Access Compliance Report

Public Rights-of-Way

Intersection ID: 24497	Main Street: BARDSTOWN_RD	Cross Street: MARYHURST_LN	Location: SW
ADA ID: 51BEF28FB6A9	Ramp Type: PerpDiag	Initial Pass/Fail: Fail	Overall Compliance: No
		Severity Score: 12.5

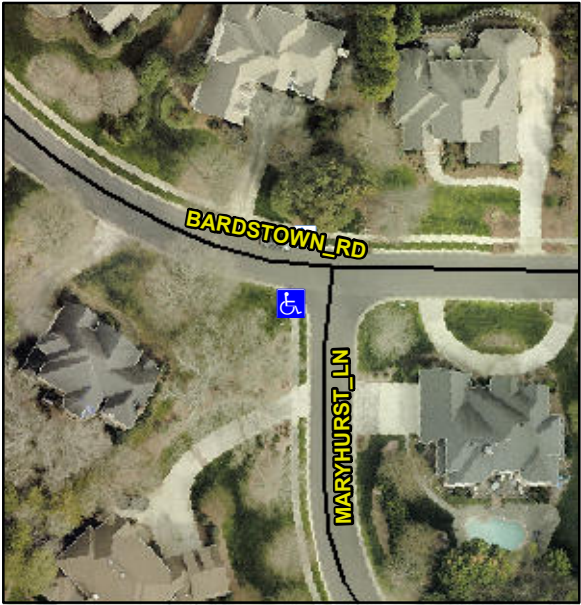
1.9	X Walk 1 Slope (%)	7.1
			5.7	X Walk 1 X Slope (%)	0.5
			N/A	Ramp inside XWalk1?	N/A
			5.4	Road Slope (%)	N/A
			5.1	Road X Slope (%)	N/A
			N/A	Any Obstructions?	N/A
			N/A	Obstruction Type	N/A
			N/A		N/A
			Yes	Surface Condition? (G/P)	Good

R304.5.3

Remove & Replace Curb Ramp With Two New Directional Ramps or Equivalent.
